TVA-BFN-TS-431

**BROWNS FERRY NUCLEAR PLANT (BFN) - UNIT 1 - TECHNICAL
SPECIFICATIONS (TS) CHANGE TS-431 - EXTENDED POWER UPRATE
(EPU) - RESPONSE TO NRC ROUND 6 REQUEST FOR ADDITIONAL
INFORMATION ON GE METHODS (TAC NO. MC3812)**

TECHNICAL SPECIFICATIONS (TS) CHANGE TS-431 - EXTENDED POWER
UPRATE (EPU) - RESPONSE TO NRC ROUND 6 REQUEST FOR ADDITIONAL
INFORMATION ON GE METHODS (TAC NO. MC3812)

Figure SBWB-27-1 Browns Ferry 1 Cycle 7 Core Loading Pattern

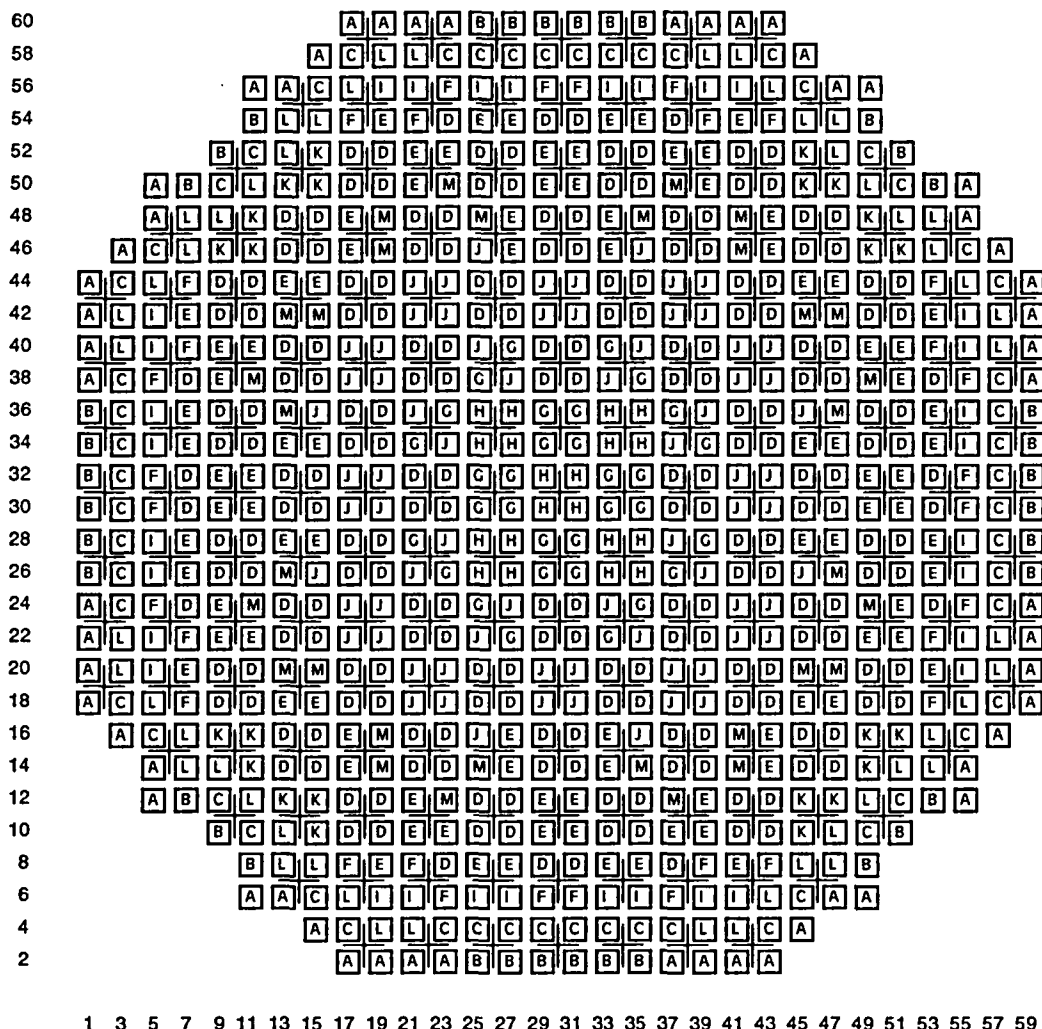
Provide quarter core map (assuming core symmetry) showing the bundle maximum linear heat generation rate and the minimum critical power ratio for beginning-of-cycle, middle-of-cycle and EOC. Similarly, show the associated bundle powers and exposures.

The information is based on the Browns Ferry Unit 1 Cycle 7 Core Loading Pattern shown in Figure SBWB-27-1, which was previously submitted to NRC on May 15, 2006, as part of the Unit 1 Reload Licensing Report (ADAMS Accession No. ML061450390).
